IEEE 802.11
Wireless Access Method and Physical Specification

Title: **Proposed Revision to 94/068**
Section 3. - FHSS PLCP Sublayer

Date: May 9, 1994

Figure 9.2-1. PLCP Frame Format

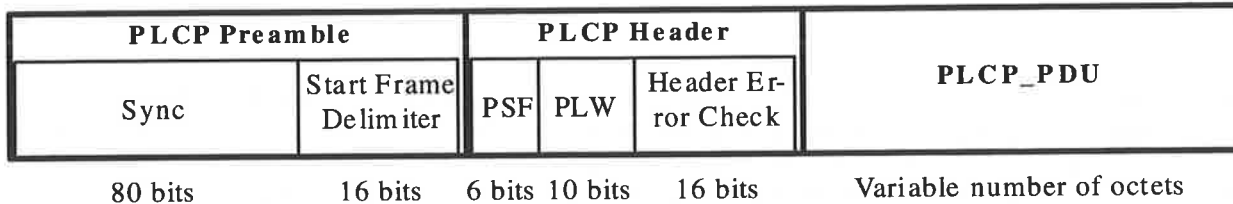
9.2.2 Physical Layer Convergence Procedure Frame Format. ~~Doc 2xx~~ The PLCP Frame Format provides for the asynchronous transfer of MAC Layer MPDU from any transmitting node to all receiving nodes within the wireless LAN. The PLCP frame format illustrated in Figure 9.2-1 consists of three parts: a PLCP Preamble, a PLCP Header, and a PLCP PDU. The PLCP Preamble provides a period of time for several receiver functions. These functions include antenna diversity, clock and data recovery and data delineation of the PLCP Header and the PLCP PDU. The PLCP Header is used to specify the length of the MPDU field and support any PLCP management information. The PLCP PDU contains the MPDU data modified by the MPDU data whitener.

~~3.3 PLCP Field Definitions~~ The PLCP packet illustrated in Figure 3-1 contains three distinct fields: PLCP Preamble, PLCP Header, and the MPDU PLCP_PDU.

Figure 9.2-2 Transmit State Machine

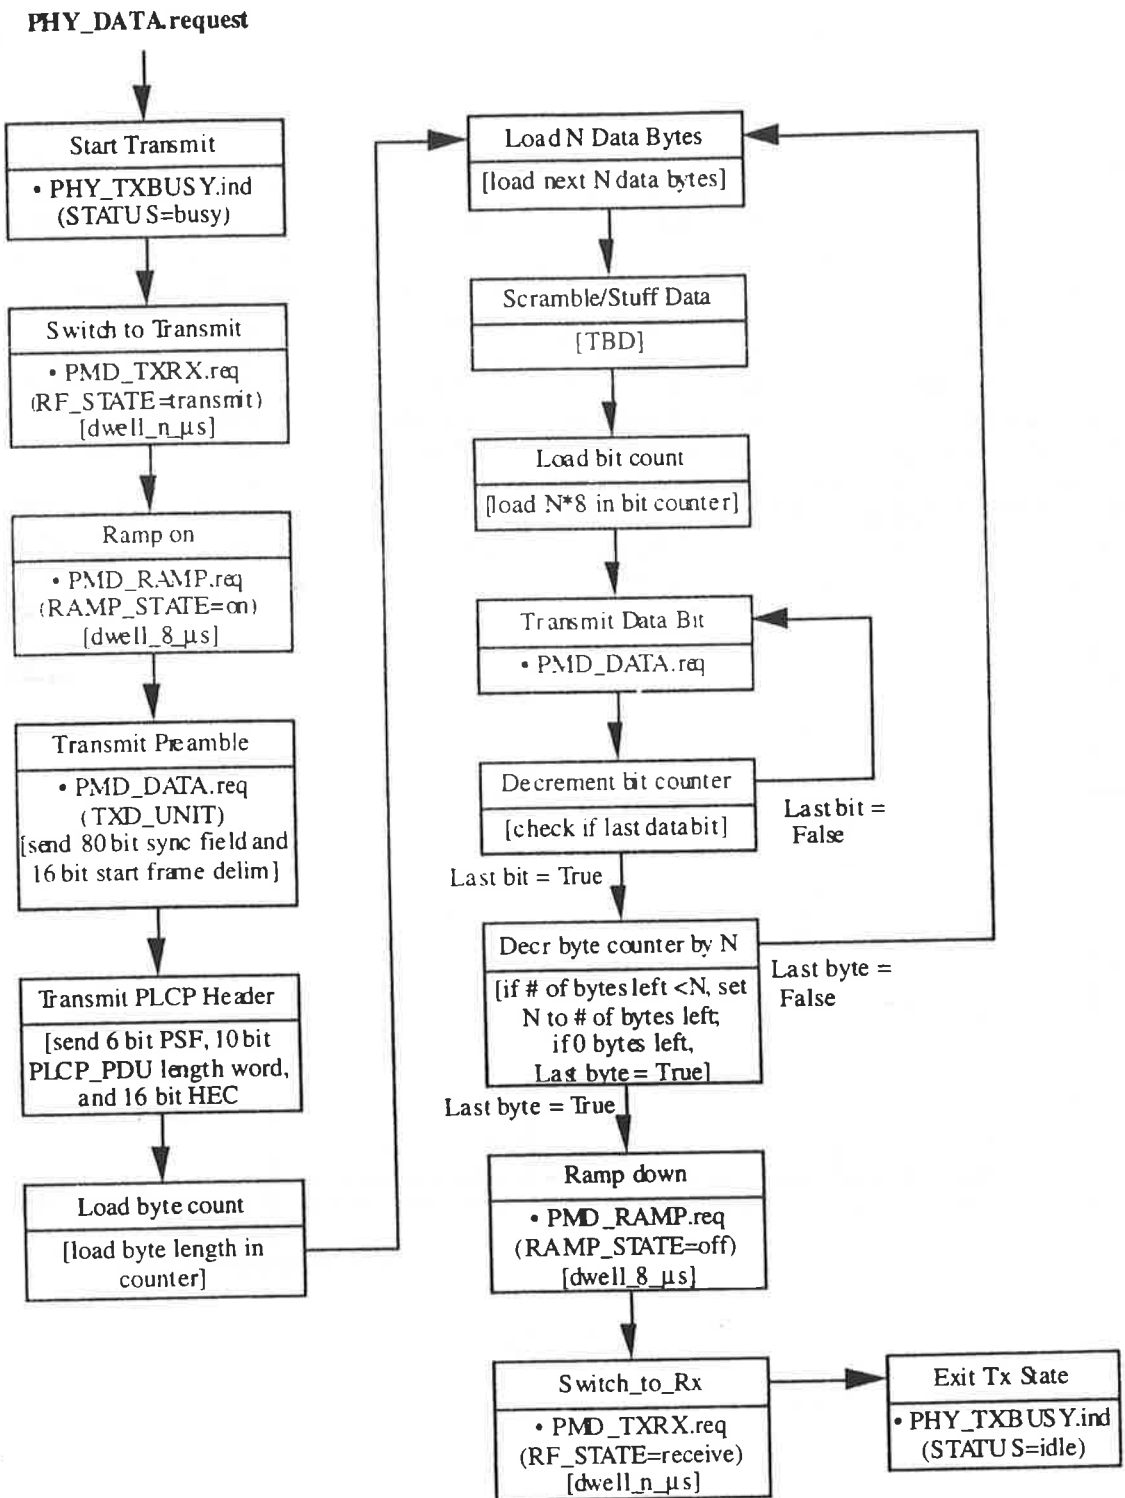
9.2.3.1 Transmit State Machine. The PLCP transmit procedure illustrated in Figure 9.2-2 includes functions that must be performed prior to, during, and after MPDU data transmission. Before transmitting the first MPDU data bit, the PLCP shall send a PHY_TXBUSY.indicate (STATUS=busy) message to the MAC; switch the PHY PMD circuitry from receive to transmit state; turn ramp on the transmit power amplifier in the manner prescribed in Section 4 (PMD specification); and transmit the preamble sync pattern and start frame delimiter, and PLCP header. The PLCP shall generate the PLCP header as defined in Section 9.2.2.2 (PLCP Header) in sufficient time to send the bits at their designated bit slot time. The PLCP shall add the PLCP header to the start of the PLCP_PDU data. During transmission of the MPDU PLCP_PDU data, each bit of the MPDU passed down from the MAC shall be processed by the TBD scrambling/stuffing operation and a counter shall be maintained to indicate the last bit of the MPDU. The PLCP_PDU data bytes are processed and transmitted MSB first and LSB last. After the last bit of the MPDU is sent PLCP_PDU data has completed propagation through the radio and been transmitted onto the air, the PLCP shall ramp turn off the power amplifier in the manner prescribed in the PMD section and send a PHY_TXBUSY.indicate(STATUS=idle) message to the MAC layer.

Figure 9.2-3 Transmit State Timing

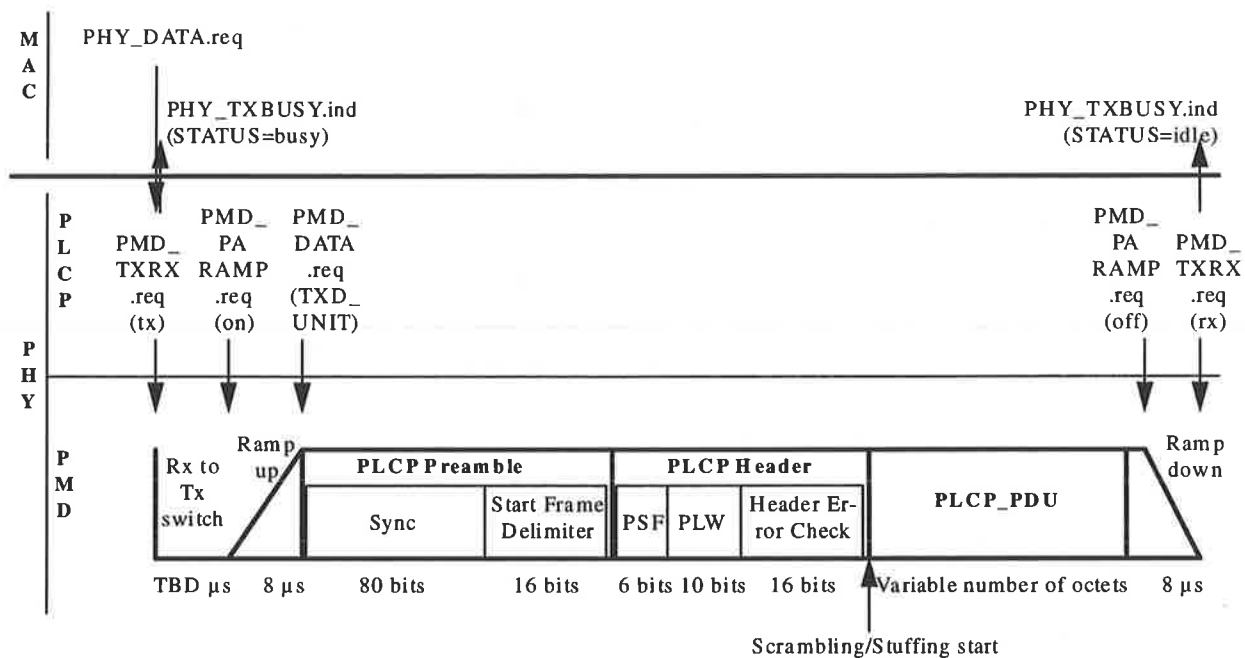
9.2.3.2 Transmit State Timing. The transmit timing illustrated in Figure 9.2-3 is defined from the instant that the PHY_DATA.request is received from the MAC layer. The PLCP shall send a PHY_TXBUSY.indicate (STATUS=busy) message to the MAC within 1 μ s of receipt of the PHY_DATA.request. The PMD circuitry shall be switched from receive to transmit and settled within TBD μ s. The power amplifier shall be turned on and settled within the specified range about the final transmit power level 8 μ s after the receive to transmit switch time. The PLCP preamble shall be transmitted at 1 Mbps and be completed within 96 μ s. The scrambling/stuffing algorithm shall be enabled with the first bit following the preamble start frame delimiter. The PLCP header shall be transmitted at 1 Mbps and be completed within ~~TBD~~ bit times 32 μ s. The variable length MPDU PLCP PDU shall be transmitted at the selected data rate. Each byte of the MPDU data shall be sent with the most significant bit of each byte first and the least significant bit last. After the last bit of the MPDU PLCP PDU data has been transmitted completed propagation through the radio and been transmitted onto the air, the PLCP shall turn off the power amplifier and be less than the specified off-mode transmit power in 8 μ s. At the end of the power amplifier ramp down period, the PLCP shall send a PHY_TXBUSY.indicate(STATUS=idle) message to the MAC layer and switch the PMD circuitry from transmit to receive. Upon completion of the transmit procedure, the PLCP shall return to the PLCP carrier sense procedure.

Figure 9.2-84 Receive State Machine

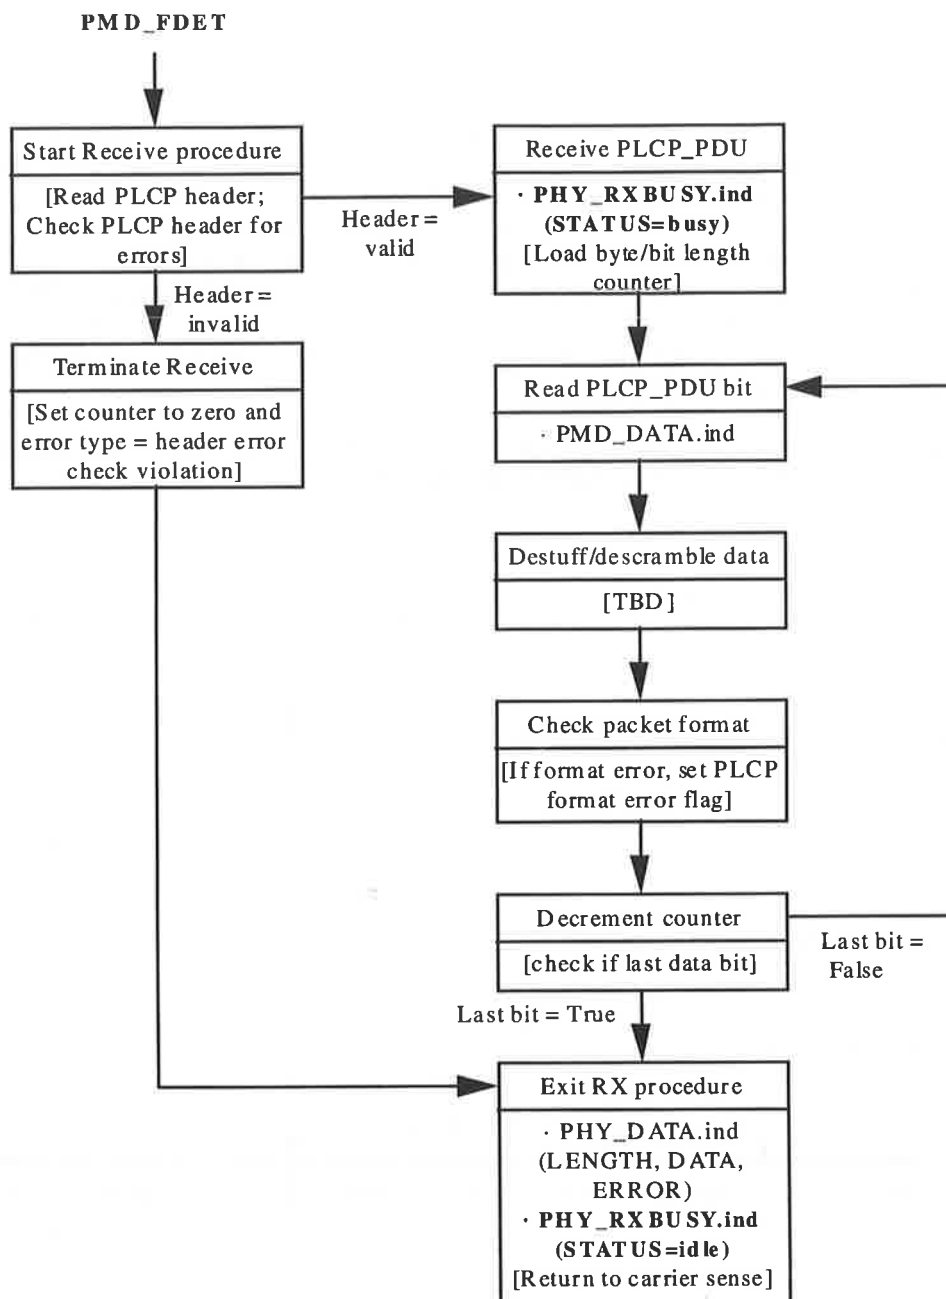
9.2.5.1 Receive State Machine. The PLCP receive procedure shown in Figure 9.2-8 includes functions that must be performed while receiving the PLCP header and the MPDU PLCP PDU data. The PLCP receive procedure begins upon detection of a complete start frame delimiter in the carrier sense procedure. The PLCP shall read in the 32-bit PLCP header and perform an error check using the header error check field. Immediately upon detection of a valid start frame delimiter, start of the PLCP receive procedure the PLCP shall send a PHY_RXBUSY.indicate(STATUS=busy) message to the MAC layer. ~~While receiving the PLCP header, the PLCP shall read the TBD length word, TBD PHY signaling field, and TBD FEC field, and perform a TBD error check/correction.~~ If the PLCP header is free or corrected of errors, the PLCP shall set a PLCP PDU byte/bit counter to indicate the last bit of the packet, receive the MPDU PLCP PDU data bits and perform the TBD descrambling/ unstuffing procedure on each MPDU PLCP PDU bit. After the last MPDU PLCP PDU bit is received, the PLCP shall send a PHY_DATA.indicate(length, data) message and a PHY_RXBUSY.indicate(STATUS=idle) message to the MAC layer. Upon completion of

If the PLCP header contains uncorrectable errors, the PLCP shall immediately set the byte/bit counter to zero, complete the receive procedure with a PHY DATA.indicate(LENGTH = 0, DATA=0, ERROR TYPE = header error check violation) and a PHY RXBUSY.indicate (STATUS=idle) to the MAC, and return to the carrier sense procedure. ~~send a PHY_RXERROR.indicate message to the MAC layer and exit the receive procedure.~~ If any other error was detected during the reception of the packet, the PLCP shall include the error type parameter in the PHY DATA.indicate message at the normal termination time as determined by the PLCP PDU byte/bit counter.

Figure 9.2-95 Receive Timing

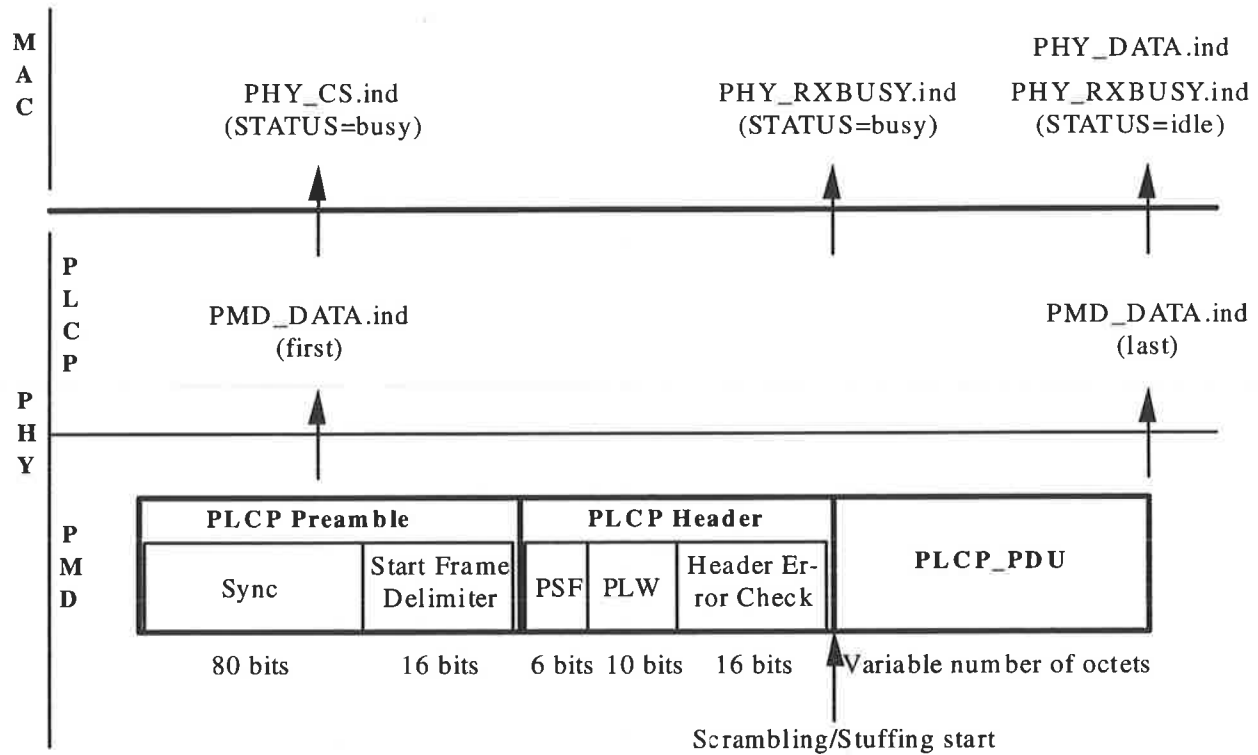
9.2.5.2 Receive State Timing. The receive state timing shown in Figure 9.2-9 is defined at the end of the last bit of the to begin upon detection of a complete start frame delimiter in the carrier sense procedure when the PMD_FDET is generated. The PLCP shall read in the PLCP header and generate a PHY_RXBUSY.indicate message to the MAC layer within 1 μs of receiving the last bit of a valid PLCP header. The PLCP shall read in the TBD_MPDU length indicator and TBD_PHY signaling field of the PLCP header and calculate and preload the byte/bit count in the counter within TBD 8 μs of the last bit of a valid PLCP header the length indicator. The PLCP shall read in the TBD header error check field and perform the check within TBD μs of the last bit of the error check field. The PLCP shall begin receiving the variable length MPDU PLCP PDU immediately after the end of the last bit of the PLCP header. The PLCP shall send the PHY_RXBUSY.indicate (STATUS=idle) and PHY_DATA.indicate messages within 1 μs of receiving the last PLCP PDU data bit.

If there was an uncorrectable error in the PLCP header, the PLCP shall terminate the receive procedure within 8 μs of the start of the MPDU PLCP PDU.
